Sancrox Quarry Expansion

Response to submissions - Water

INDEPENDENT PEER REVIEW OF SANCROX QUARRY EXPANSION GROUNDWATER MODEL

GW-HANSON-20-02-REP-001

Figure 2-1 Groundwater monitoring bores

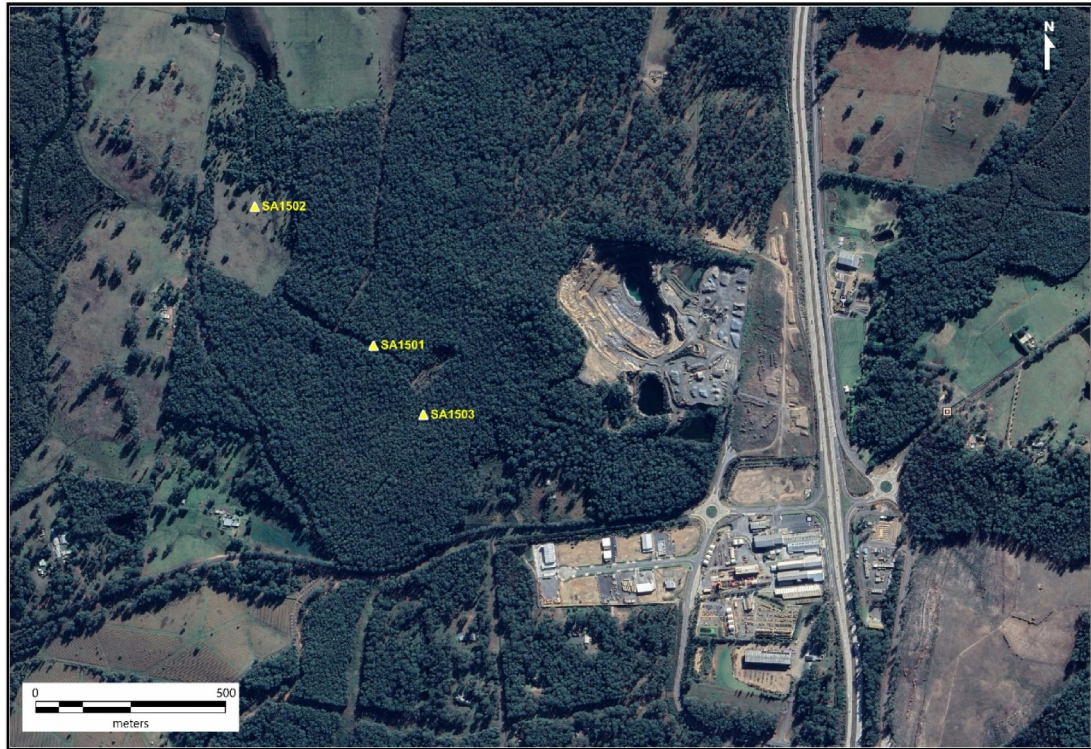
These bores are located in a near straight line which is not ideal for inferring groundwater flow directions spatially within the study area. Historical water levels that were collected from these bores were neither provided nor analysed to understand the hydrological stresses. It is also noted that no hydrogeological information from the surrounding groundwater bores, GW060512, GW060513, GW300120, GW301263, GW302376, GW303436, GW303749 and GW306269, has been included in the groundwater model development.

Figure 2-4 Plot of residual and monthly rainfall

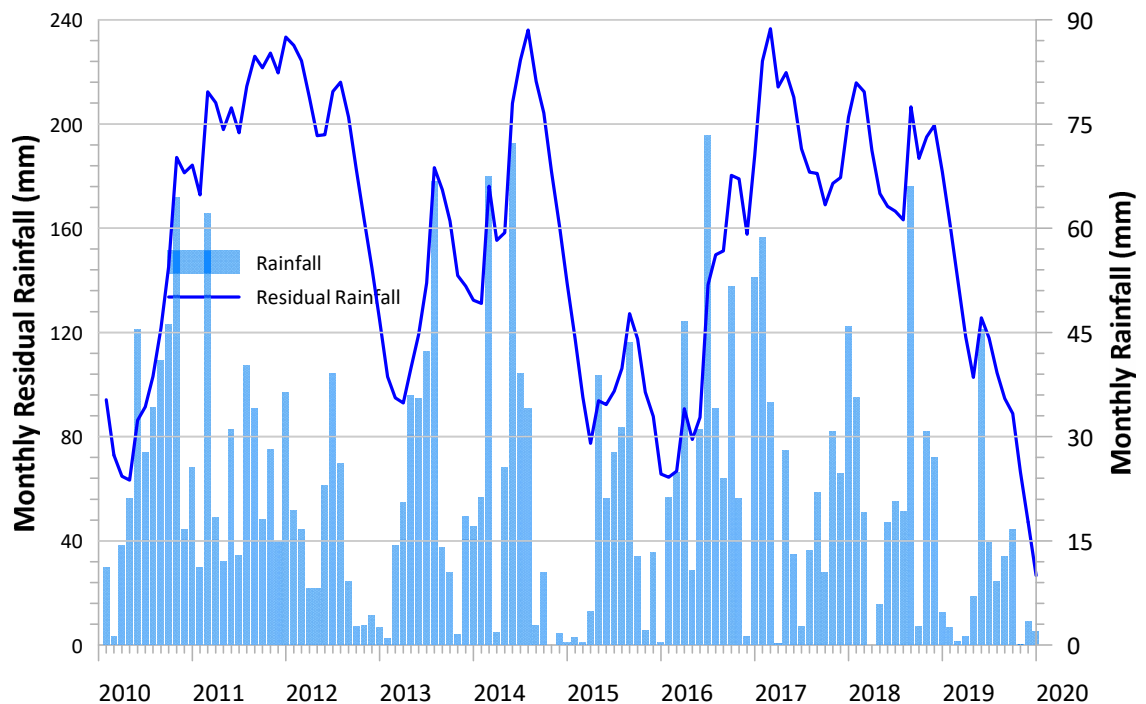
No verification of the model performance was reported. Verification is a test of whether the model can be used as a predictive tool by demonstrating that the calibrated model is an adequate representation of the physical system. The steady state model has been calibrated based on the groundwater elevation data collected on 28 November 2017 and the rainfall data available for the site from the DataDrill⁵ climate repository (**Figure 2-4**) indicates that the Study Area experienced more than average rainfall in the latter part of 2017.

Consideration should be given to verification of the model using the logger data to assess if the model is a reliable tool for the prediction of groundwater level fluctuation with varying climate data.
